# Access Compliance Report

## Public Rights-of-Way

### (Curb Ramps)

Intersection ID: 50588	Main Street: BENDING_BRANCH_RD	Cross Street: DOWNY_BIRCH_RD	Location: NW
ADA ID: A37A8736B51C	Ramp Type: Perp	Initial Pass/Fail: Fail	Overall Compliance: No
Severity Score: 8.75			
Codes/Mitigation Info/Possible Solution		Field Measurements/Component Compliance

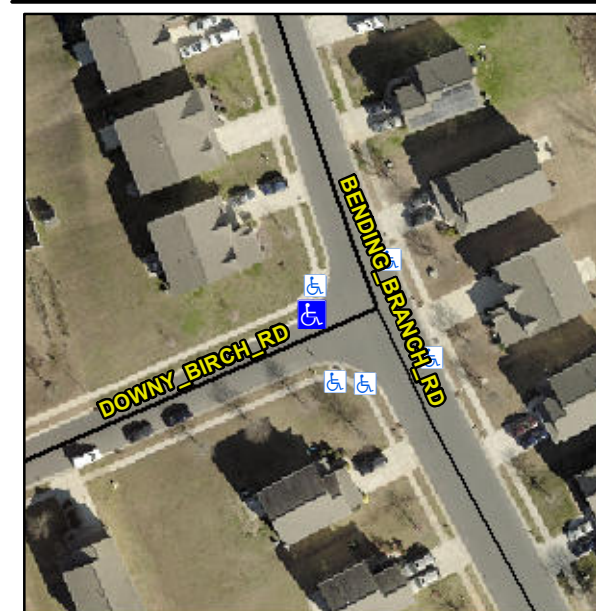
**Not Found, R304.5.1**

Compliance	Description	Data	Compliance	Description	Data
N/A	Ramp Length (in)	48.5	Yes	Ramp Slope (%)	7.4
No	Ramp Width (in)	47.5	Yes	Ramp XSlope (%)	1.0
N/A	Flare Type LT	N/A	N/A	Flare Type RT	N/A
N/A	Flare Slope LT (%)	N/A	N/A	Flare Slope RT (%)	N/A
N/A	Flare Traversable LT?	N/A	N/A	Flare Traversable RT?	N/A
N/A	Landing Length (in)	N/A	N/A	DWS Provided?	N/A
N/A	Landing Width (in)	N/A	N/A	DWS Contrast?	N/A
N/A	Landing Slope (%)	N/A	N/A	DWS Length (in)	N/A
N/A	Landing X Slope (%)	N/A	N/A	DWS Full Width?	N/A
N/A	Landing Curb? (Y/N)	N/A	N/A	DWS Offset (in)	N/A
N/A	Shared Landing?	N/A			
N/A	Gutter Ponding?	N/A	N/A	Gutter Slope (%)	N/A
N/A	Gutter Lip Ht (in)	N/A	N/A	Gutter X Slope (%)	N/A
N/A	Painted X Walk1?	No	N/A	Painted X Walk2?	N/A
	X Walk 1 Direction	To S		X Walk 2 Direction	N/A
N/A	X Walk 1 Width (in)	N/A	N/A	X Walk 2 Width (in)	N/A
	X Walk 1 Slope (%)	2.6		X Walk 2 Slope (%)	N/A
	X Walk 1 X Slope (%)	1.4		X Walk 2 X Slope (%)	N/A

**Remove & Replace Entire Ramp.**
